U.S. MAGNET
DEVELOPMENT
PROGRAM

MDPCT1 coil 5 CT scan

U.S. MDP Collaboration Meeting
3/21/2023

“Low-density area” on RE pole turn

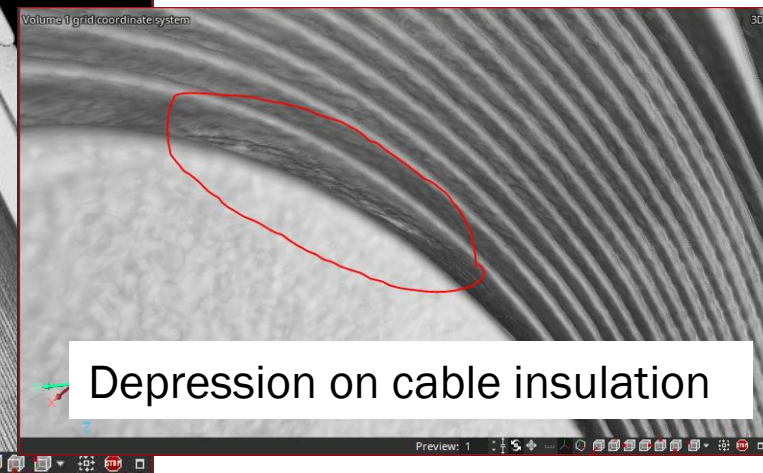
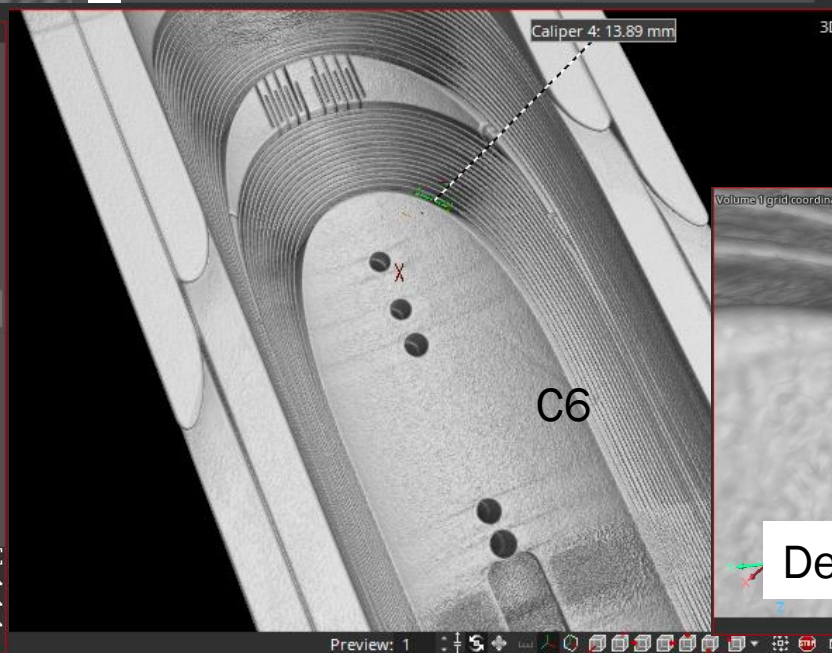
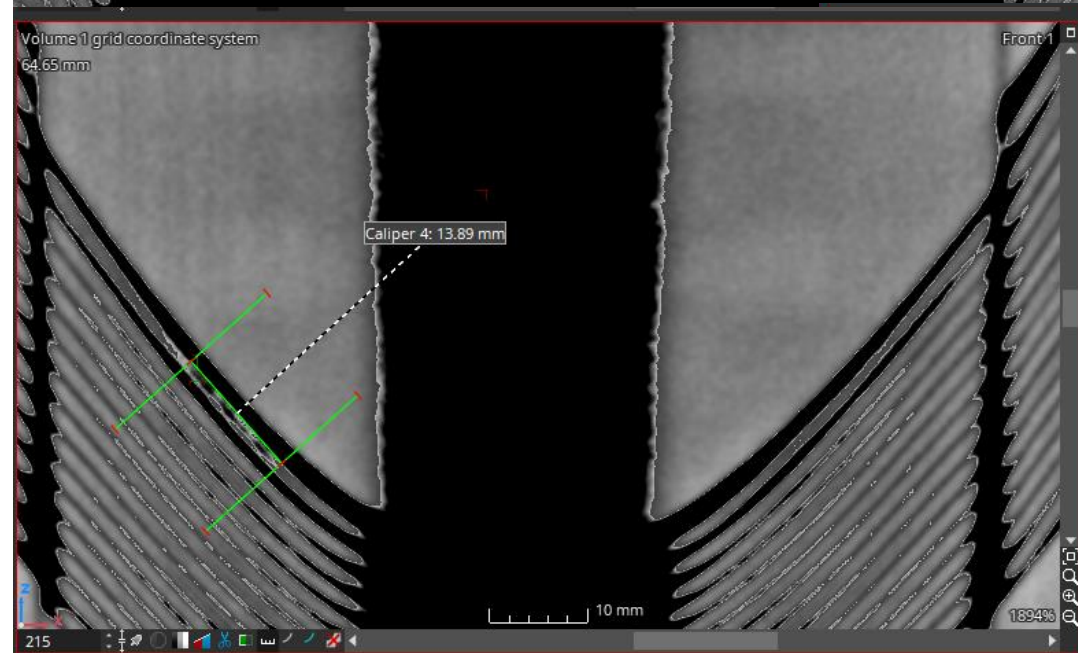
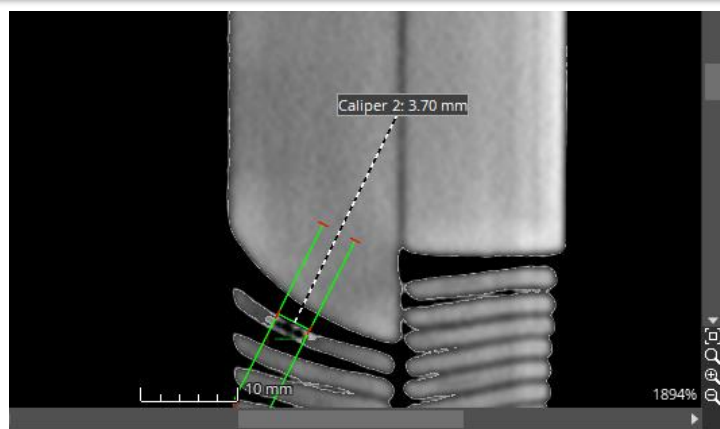
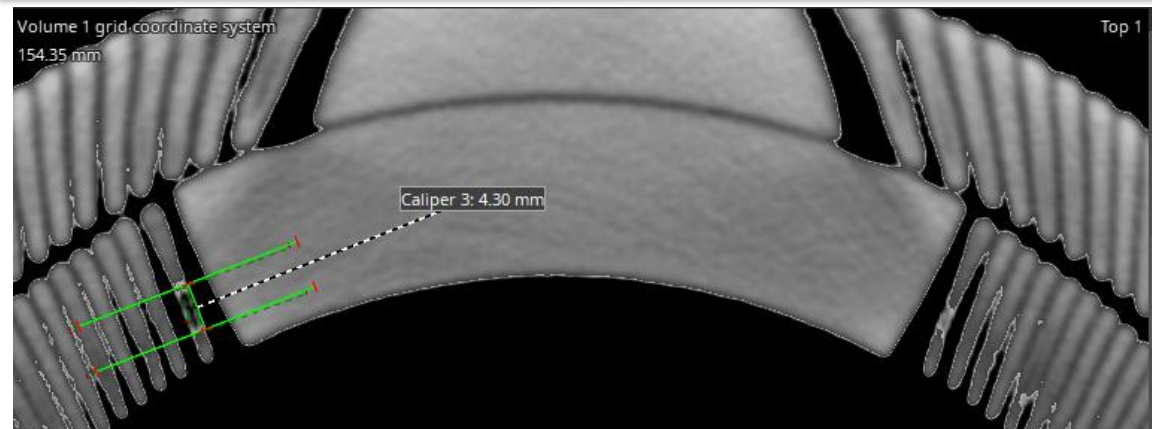
- “low-density area” size ~4.3mm x 3.7mm x 14mm
- Two symmetrical spots
- Not on the cable edge
- Depression of cable insulation on one side
- Correlates with the limited quench location

Comments from Diondo experts

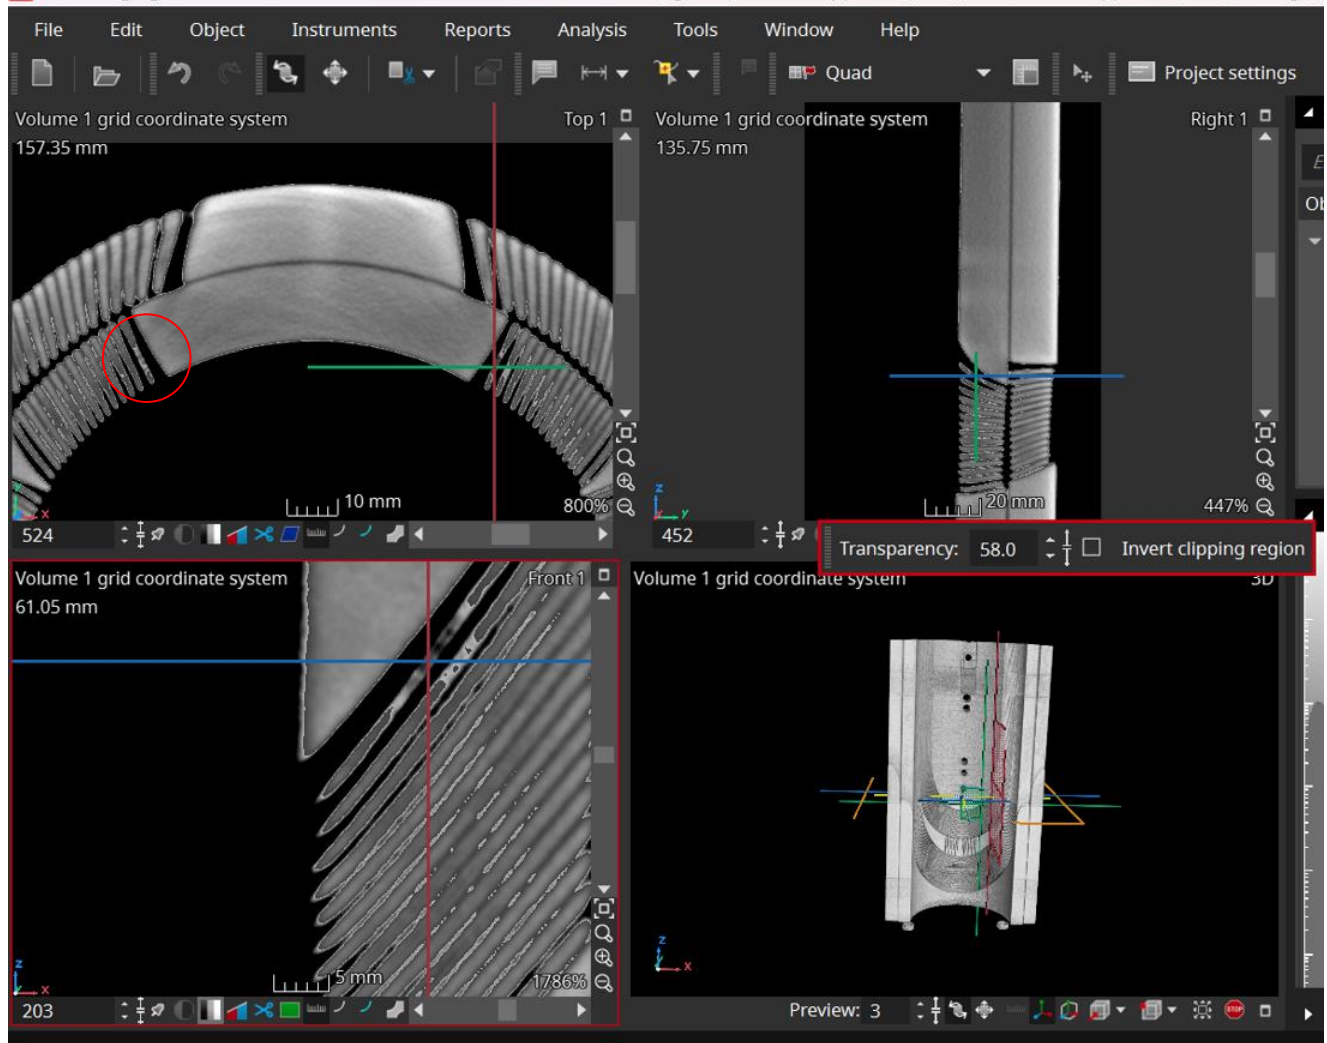
FNAL question:

In some areas along the coil ends, we see spots in pole cable cross-section on both sides (marked in the pictures). Could be interpreted as a cable properties change or it's just a software problem?

Diondo comments:

- In our opinion, it appears that the wire is stretched or smashed so the density is less. In the color and opacity mode the window and level is changed so that the contrast is much higher and it shows the surface changes.

- Also, if we manually change the window and level of the exploded area we can see changes in density. The copper strand resistance may increase with a stretching fatigue and will turn into a crack over time with heat and flexing.

- To characterize this image as a failure the part would usually be dissected which has many difficulties because the surfaces are disturbed. I included a microscopic cross section of a copper wire from a capacitor that was vibrating slightly on a PCB. We plan to use this coil to show how the wire can split and begin to overheat and eventually break.

- I don't know if this helps but it is a good bet that the strands in question may be damaged.
